TREE CONSERVATION REPORT
ADDENDUM 2.1
71 Russell Ave

Tree Conservation Report Addendum submitted as
Partial Requirements for a Site Plan Control
Application, May 29, 2026

Tree Conservation Report Addendum

Address: 71 Russell Ave
Date of Report: May 29, 2026
Date of Site Visit: April 9, 2026
Prepared by: Astrid Nielsen, RPF, ISA Certified Arborist®
101- 45 Spencer Ave, K1Y 2P5
Astrid.nielsen@dendronforestry.ca
Client: Colin Miller, Colin@pinehillbuilders.ca

Figure 1: Image clip from updated grading plan prepared by TL Mak dated May 27, 2026 showing the walkway curving around tree 1, city owned Norway maple. The distance from the edge of the tree trunk to the edge of the retaining wall is approximately 1.5 m.

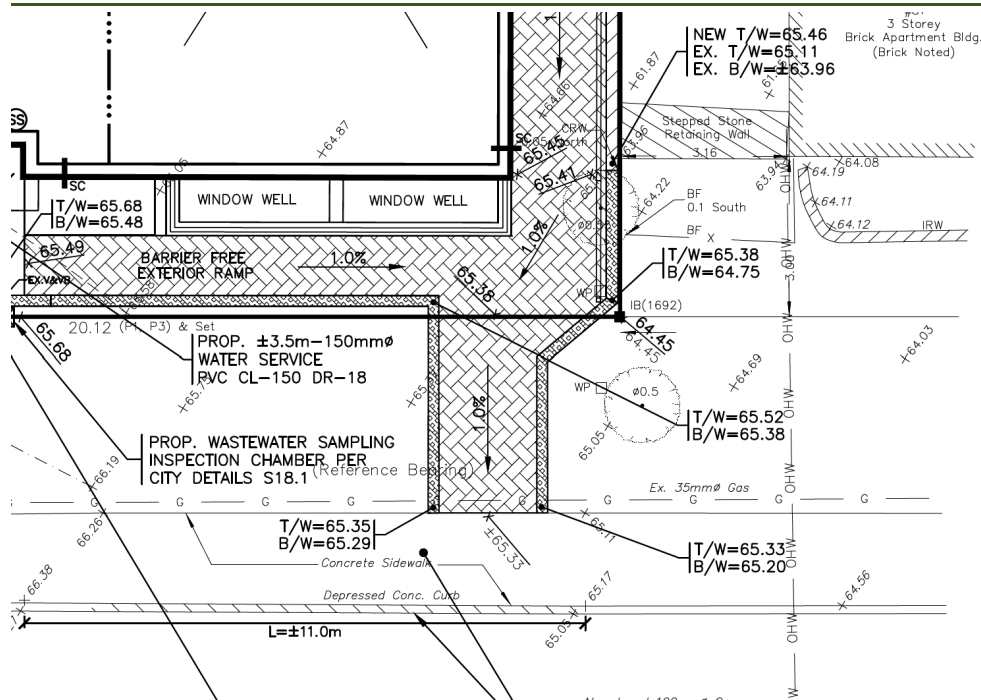
- 1. The retention plan for trees 1, 10 and 11 raises concern. Please provide more detail on the current growing condition of these trees, how much of the CRZs will be impacted by the proposed excavation and how far excavation is from the trunk of each tree. Address how the existing retaining wall beside trees 10 and 11 has influenced root growth and ensure the CRZs of these trees are accurately depicted. For tree 1, the proximity of the pavement and retaining wall is particularly concerning as it appears to be within the trees static root zone. There is concern over trees 1, 10 and 11 being made unstable by the extent of excavation/construction proposed in their proximity.

- 4. The tree protection fencing for trees 10 and 11 overlaps with the proposed stairs and with a future talkway and curb for tree 1. This is unrealistic. Please address in the TCR and provide more details on the plan and how it can be executed as planned.

Tree 1: This updated report reflects changes that were made to the grading plan for the walkway to curve around the tree. The new walkway and retaining wall will be approximately 1.5 m from the edge of the tree trunk which should avoid impacting the structural integrity of the tree. The tree roots are to be pruned in advance of any excavation for the walkway and retaining wall and be completed by a certified arborist and/or city forestry staff. The same applies to the removal of any branches for the clearance of equipment on site.
